**1958 Agreement – Consideration of draft amendments
to existing Regulations submitted by GRE**

Proposal for Supplement 5 to the original series of amendments to Regulation No. 128 (Light Emitting Diode (LED) light sources)

Submitted by the Working Party on Lighting and Light-Signalling*

The text reproduced below was adopted by the Working Party on Lighting and Light-Signalling (GRE) at its seventy-fourth session (ECE/TRANS/WP.29/GRE/74, para. 12). It is based on ECE/TRANS/WP.29/GRE/2015/30. It is submitted to the World Forum for Harmonization of Vehicle Regulations (WP.29) and to the Administrative Committee AC.1 for consideration at their March 2016 sessions.

Figure 1*

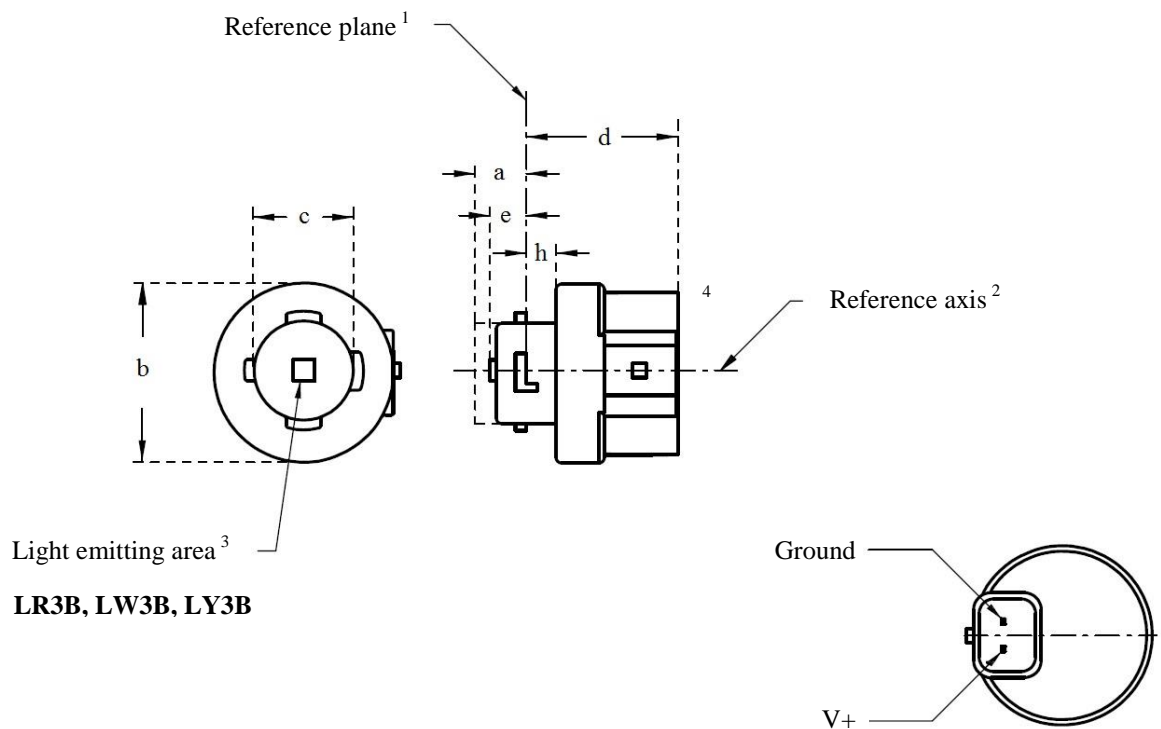
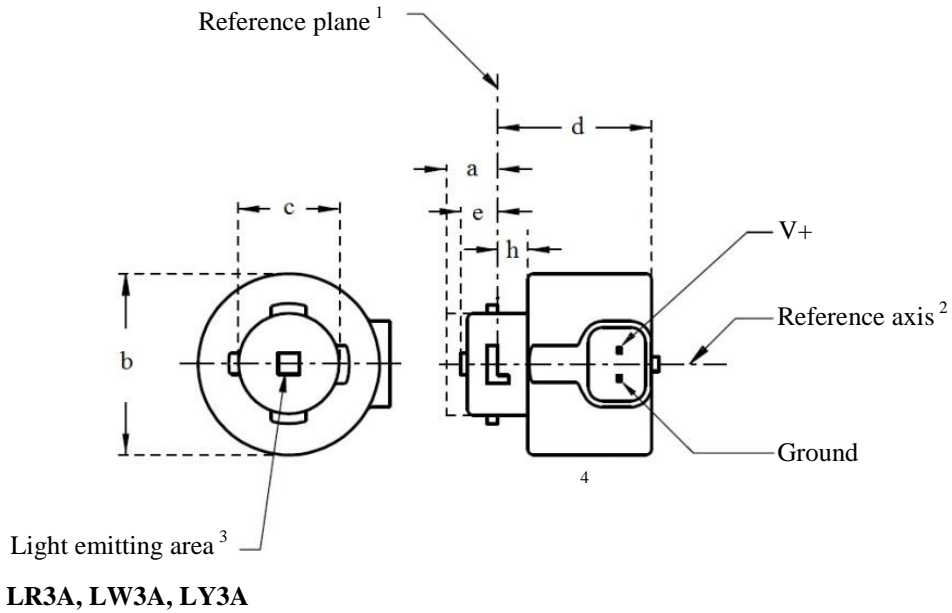
Sheets LR3/1 to 5, replace by new sheets L3/1 to 6, to read (see following pages; one page per sheet):

Figure 1*

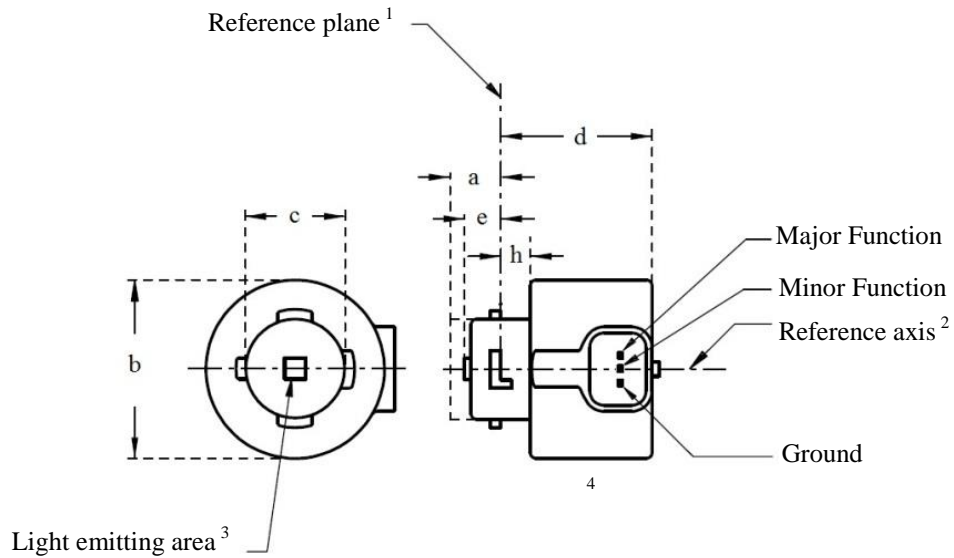
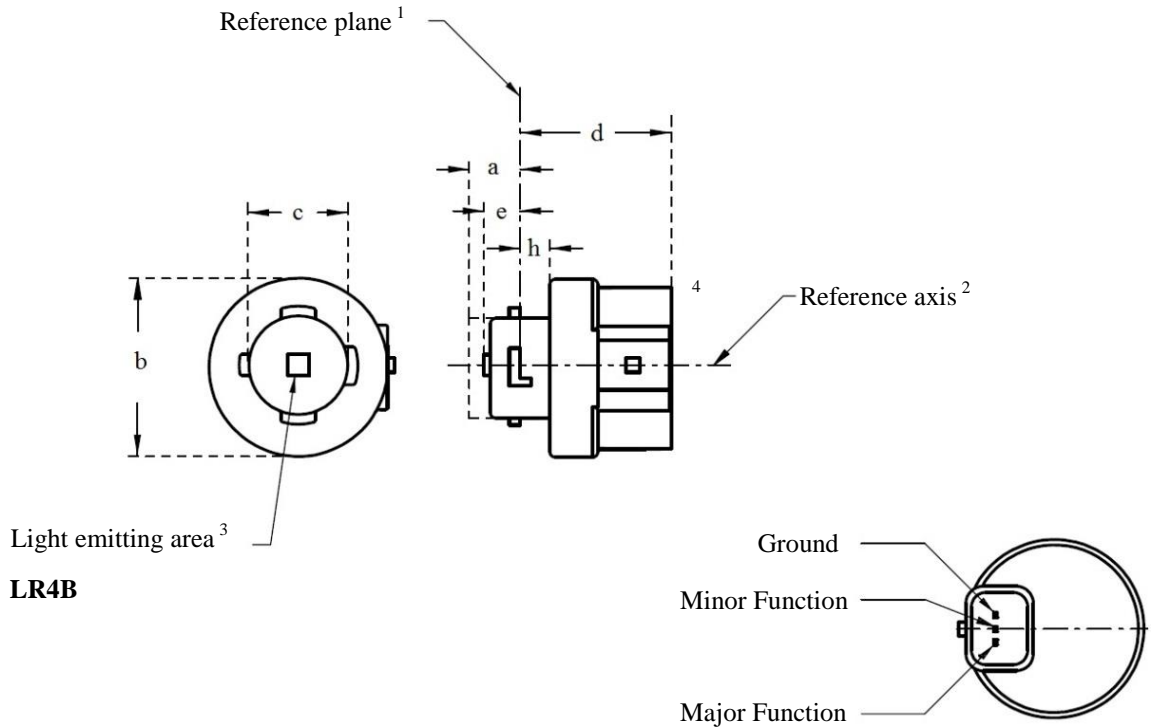
Sheet LR4/1, replace by new sheet LR4/1, to read (see following pages):

Figure 3*
Set-up to measure the luminous intensity distribution

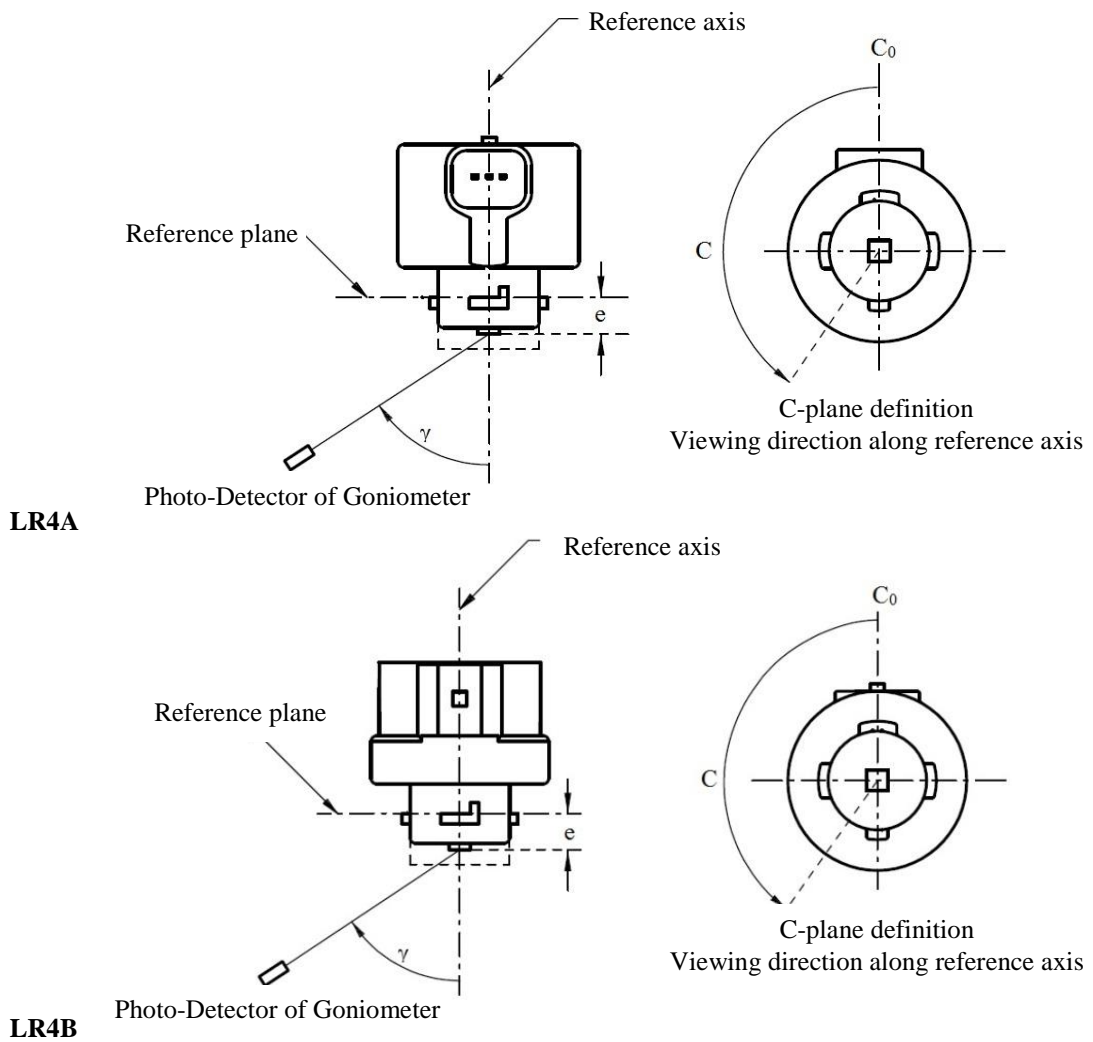
Sheet LR4/4, replace by new sheet LR4/4, to read (see following pages):

Figure 1*
Main Drawing

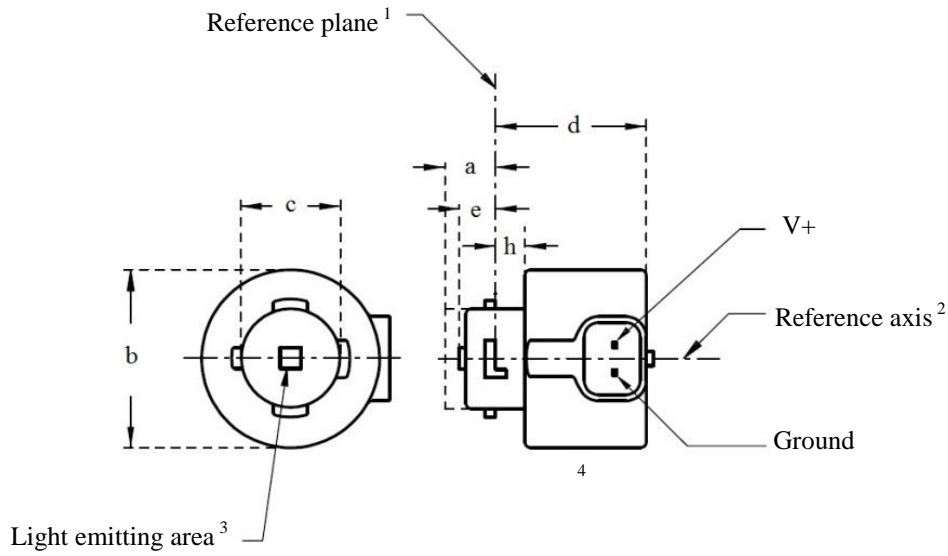
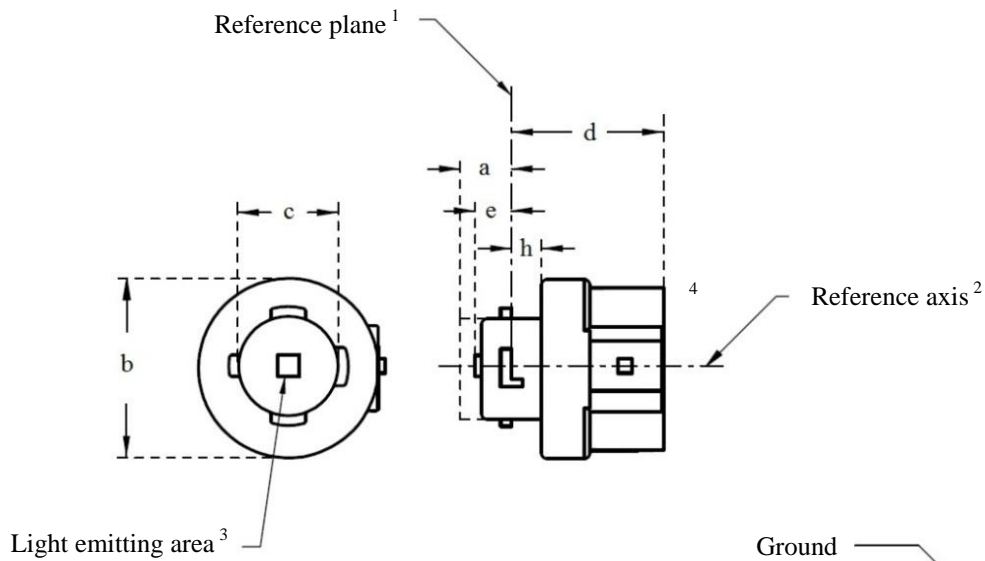
After sheet LR4/5, insert new sheets L5/1 to 6, to read (see following pages; one page per sheet):
